THE BOND

PLAN REVIEW CENTER REPORT

Revised Preliminary Site Plan

Review Date: May 21, 2024
Review Type: Revised Preliminary Site Plan
Project Name: **18-10 THE BOND (FKA THE DISTRICT)**
Plan Date: May 3, 2024
Prepared by: Lindsay Bell, Senior Planner
E-mail: lbell@cityofnovi.org **Phone:** 248.347.0484

OVERALL SITE PLAN

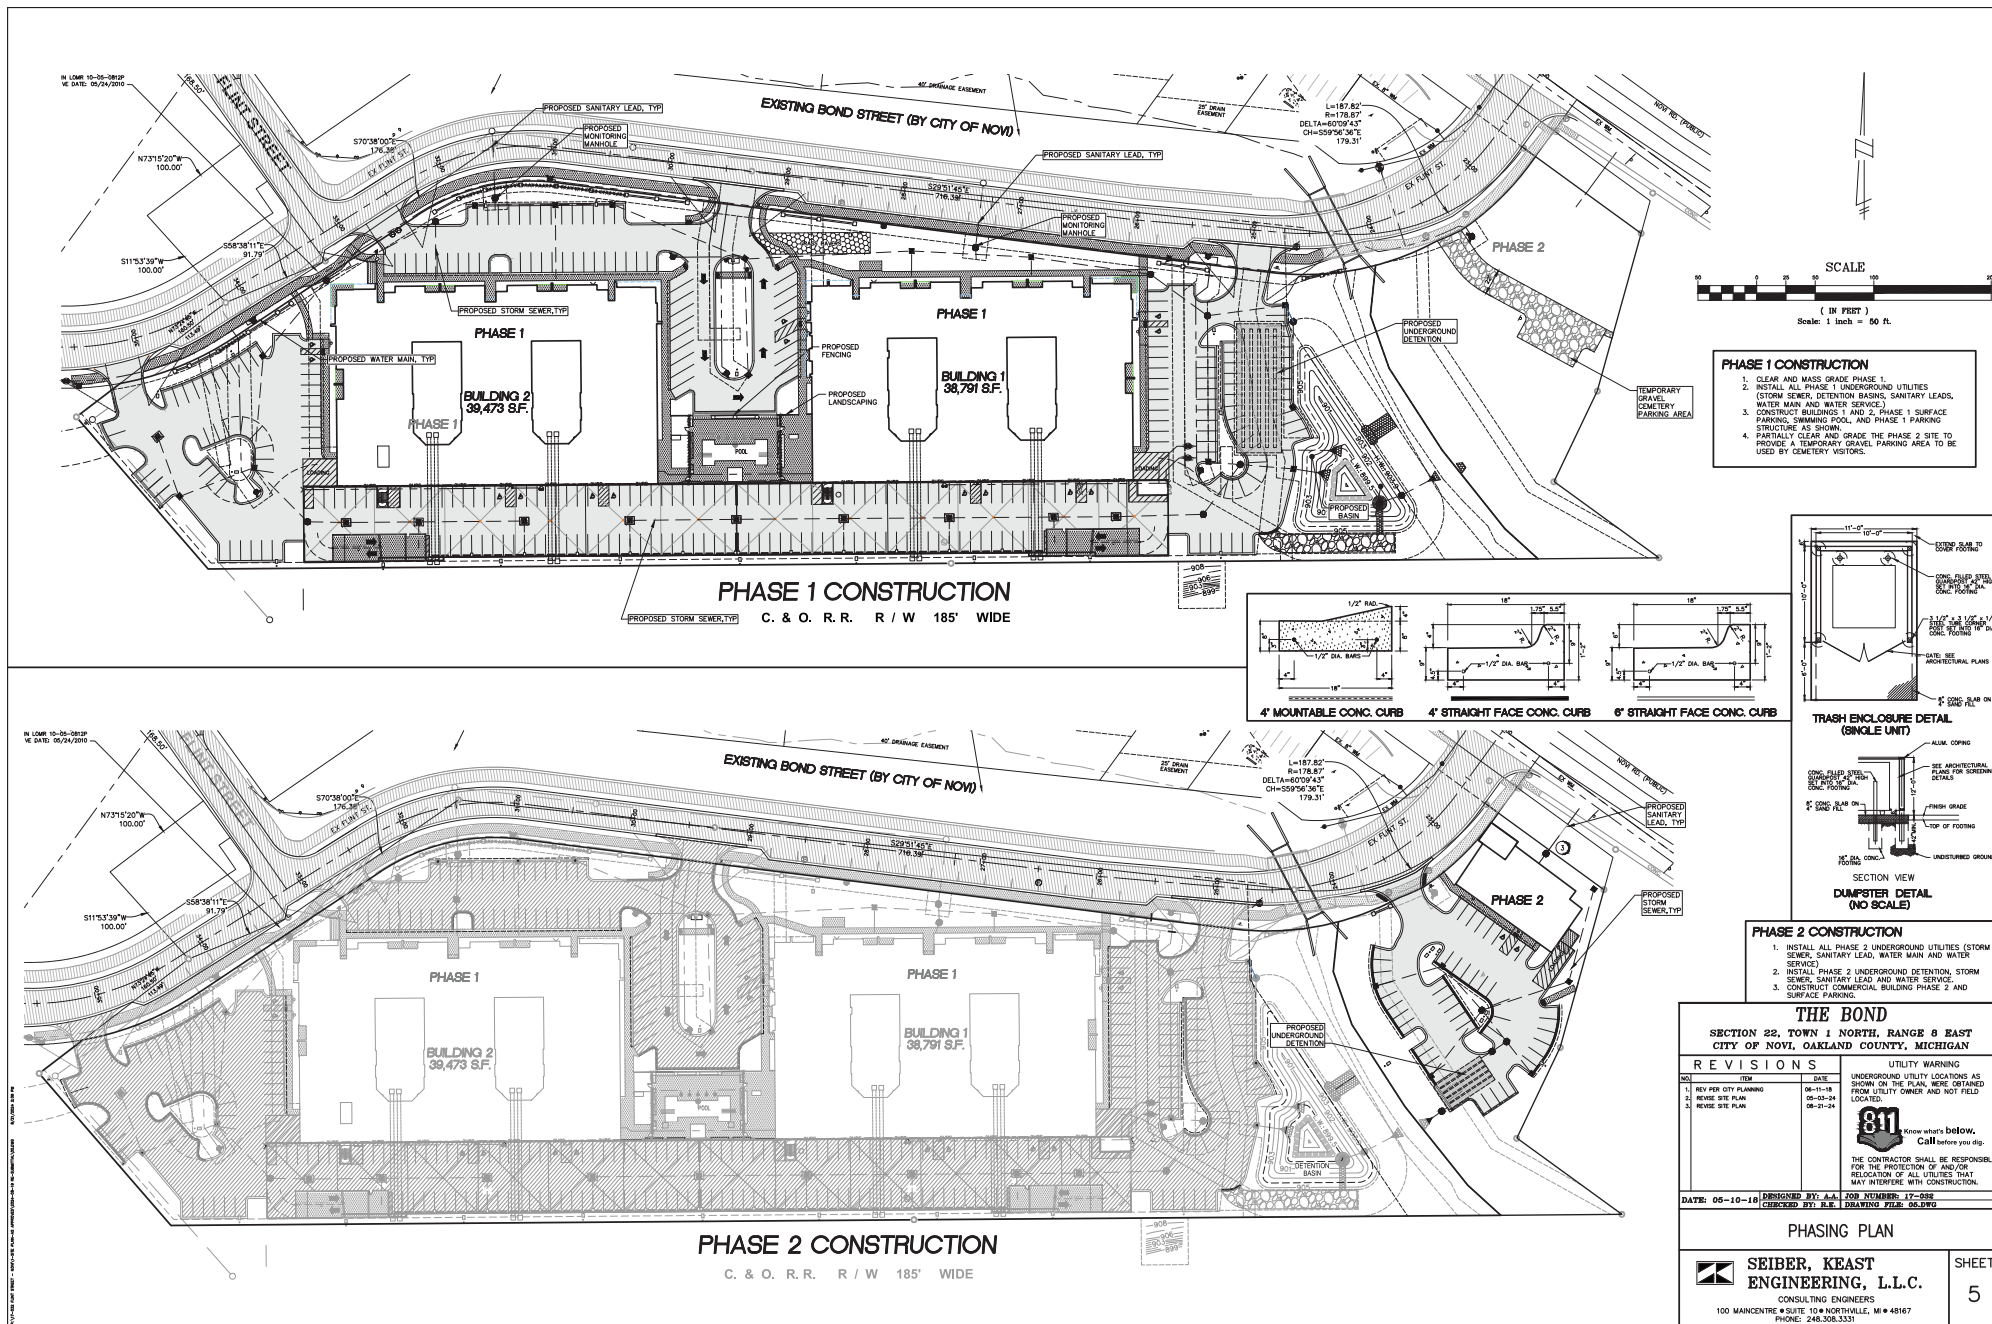
2. Current Revised Site Plan: With the current revised plan, the applicant is proposing to add a 5th story to the building with 69 additional units. **The revised site plan does not indicate significant changes to the building footprint or the site layout.** The applicant noted that the minor changes to the site plan will comply with the ordinance requirements at the time of final site plan. The site plan is subject to all previous approved conditions and deviations that will need to be revisited as a part of this Revised Preliminary Site Plan review process, including the one approved condition that is proposed to be revised. The following items will be checked for compliance at the time of final site plan.

7. Total Parking required and Proposed: After reviewing all information provided, staff recommended adding a 20% contingency to minimum required count per TC-1 requirements. The contingency would address the unknown factors such as renters demographic and occupancy rate, etc. **With the additional 69 units, a total of 557 spaces are required. The current site plan indicates a total of 562 spaces. The proposed number meets the Ordinance minimum, as well as the recommended additional 20% contingency. Note – to meet landscaping standards two parking spaces will need to be removed to provide the appropriate planting area at the two ends of the parking garage.**

Underground Storage:

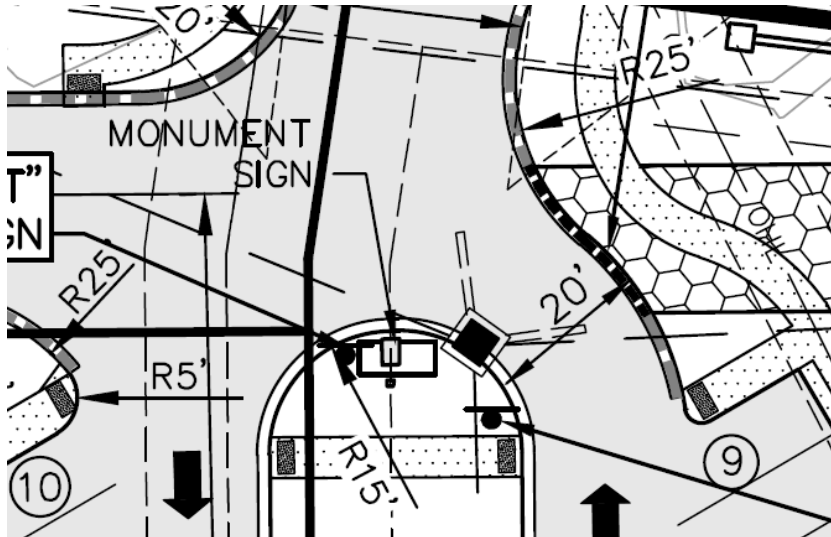
52. Provide the overland routing that would occur in the event the underground system cannot accept flow. This route shall be directed to a recognized drainage course or drainage system.
53. Provide an underdrain along the downstream side of the underground detention system which is tied into a manhole as a means of secondary storm water conveyance to the outlet.
54. Provide a soil boring in the vicinity of the proposed underground detention system to determine bearing capacity and the high-water elevation of the groundwater table.
